Davis-Besse Nuclear Power Station
Docket No. 50-346, License No. NPF-3
Response to Request for Additional Information on 10 CFR 50.55a Request RR-A37
(TAC No. MF0752)

Response to June 27, 2013 Request for Additional Information
Page 1 of 9

Figure 1
1-2 RCS COLD LEG DRAIN NOZZLE
RC-40-CCA-18-3-FW9 OVERLAY
CIRCUMFERENTIAL COVERAGE

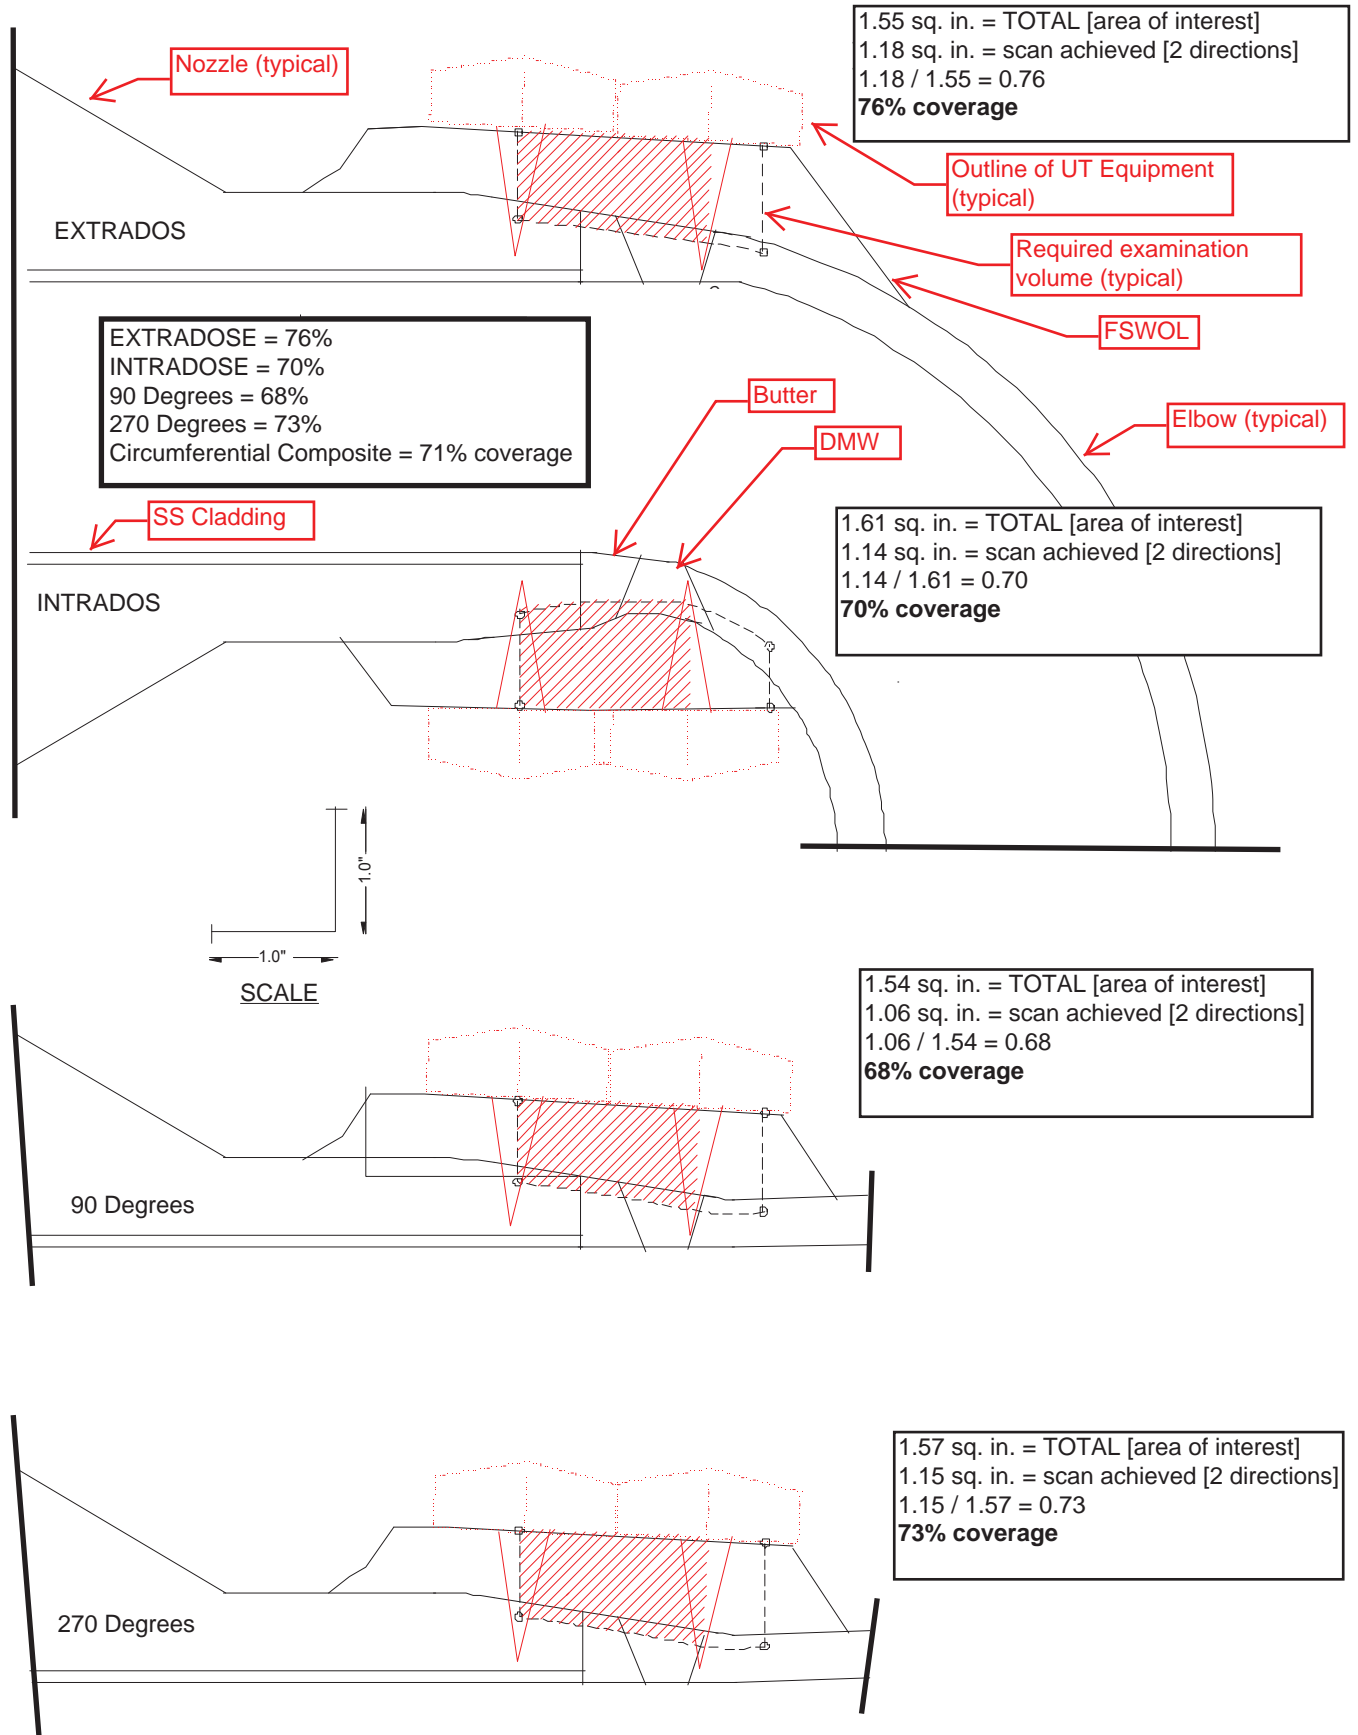
- 2. The NRC staff is unable to determine the exact volumes that were examined and the part of the required volume that was not examined from the drawings provided in the proposed alternative.**

Provide clear scale drawings (with scale indicated) of the subject DMBW [dissimilar metal butt weld], including weld butter and FSWOL [full structural weld overlay] indicated. Clearly show the American Society of Mechanical Engineers (ASME) Boiler and Pressure Vessel Code (Code) Case N-770-1 required examination volume and the volume of material interrogated by the examination in the axial and circumferential scan directions.

The requested information is provided in Figures 1 and 2.

Figure 3
1-2 RCS COLD LEG DRAIN NOZZLE
RC-40-CCA-18-3-FW9 OVERLAY
CIRCUMFERENTIAL COVERAGE

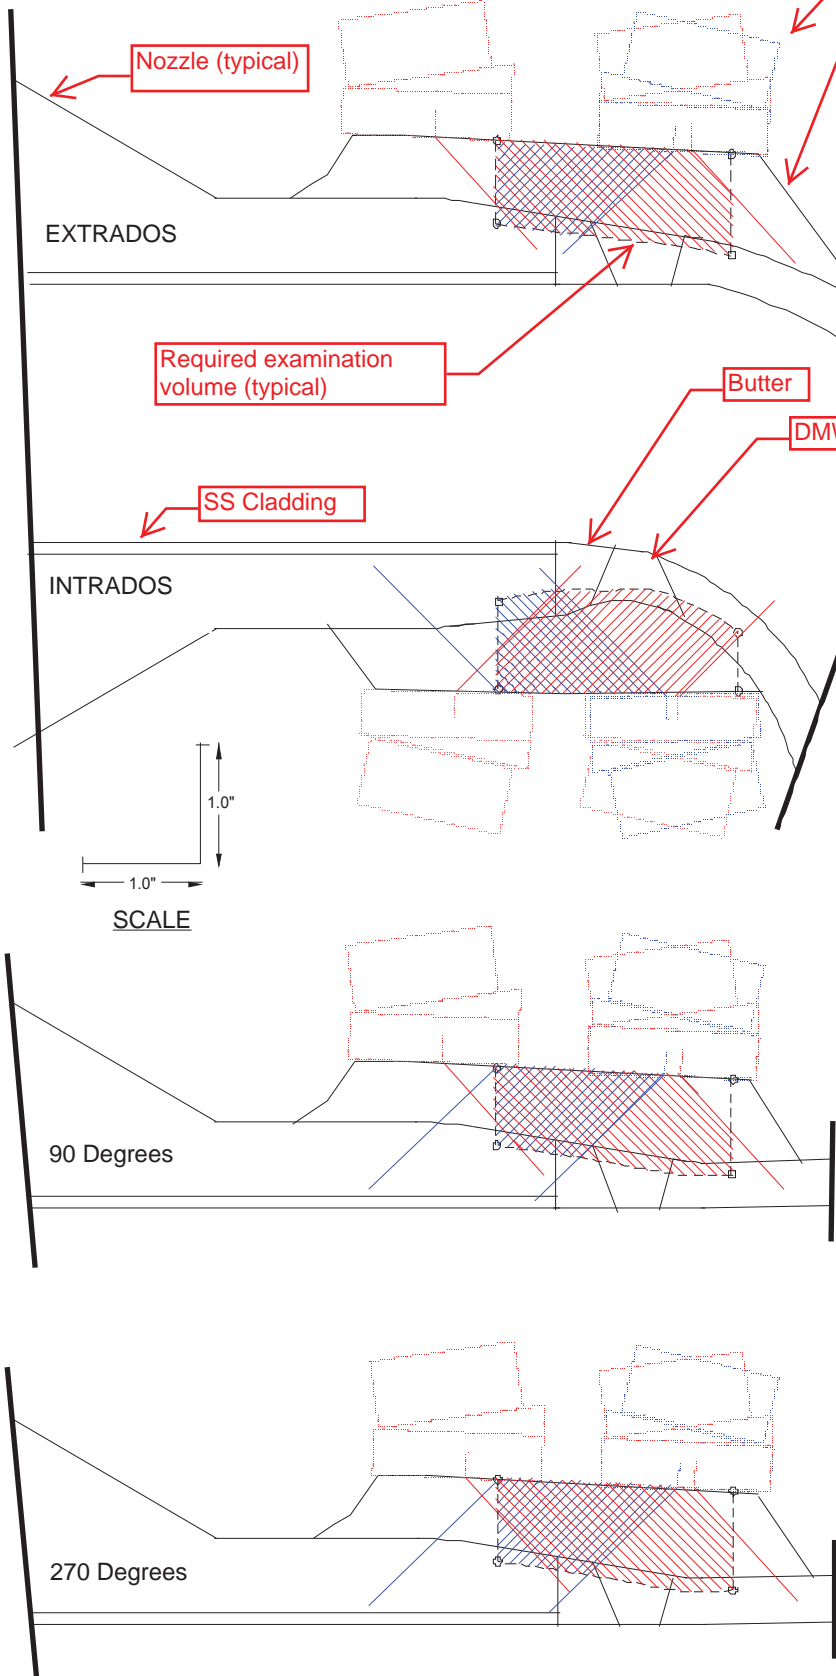
- 3. Provide a table detailing the scan coverage achieved for each of the following:**
- a. carbon steel nozzle;**
 - b. stainless steel elbow;**
 - c. susceptible weld metal; and**
 - d. full structural weld overlay.**

Provide values for scans in the circumferential and axial directions.

The requested information is provided in Figures 3 and 4 with coverage values expressed as percentages.
